## Watson Facility/Well Discussion Findings

ECMC currently has seven Supplemental Form 27s and one Initial Form 19 in process regarding the Watson E 28-17 / Watson E28-19 wells and production facilities. ECMC is taking the following actions on these forms:

### Remediation Project 33863 (Related to Location ID 421924 Watson E28-19)

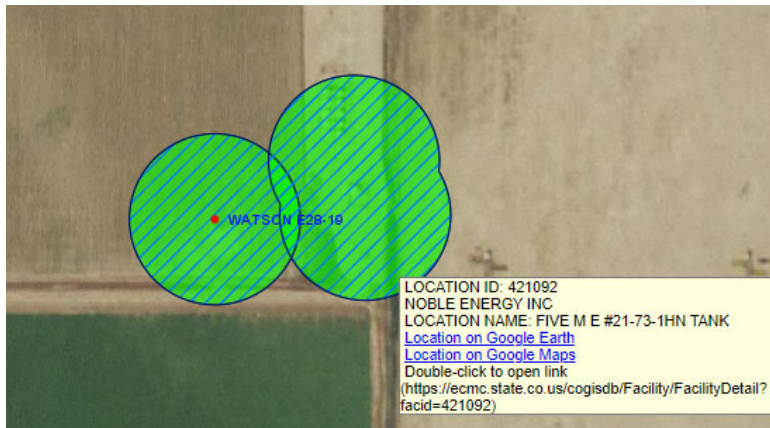
1. Below is a shot of the 28-17 Wellhead, with a **Facility that is named 28-19** to the North of the wellhead (but notice that the green hatched circle is around the wellhead, not the facility). This location ID is the same as item #2 below.

2. The 28-19 **wellhead** is located on the right side of the picture,

The wellhead, and the facility from Item # 1 have the same Location ID, however, they are not associated with each other and are ~0.5mi apart.

3. The 28-19 Wellhead flows to the facility immediately to the right. However, this area is split into two separate facilities. The northernmost end is the Five M E 21-73-1HN Facility. The southern side is where the Watson 28-19 flows. This facility does not have an ECMC Location ID, and the location bubbles currently in place are incorrect and should be further north.

The team will be resubmitting the Form 19 with a corrected site map for the Eastern Facility currently called " Watson E28-19" with a Facility ID of 421294. The lat/longs will also be corrected in the F27 Supplemental.

We would like to request the correction of the Location of the Five 21-73-1 Facility Noted above, along with the creation of a NEW facility ID for the Watson 28-19 and 28-2 wells to flow to at Lat 40.461359/ Long -104.663838.
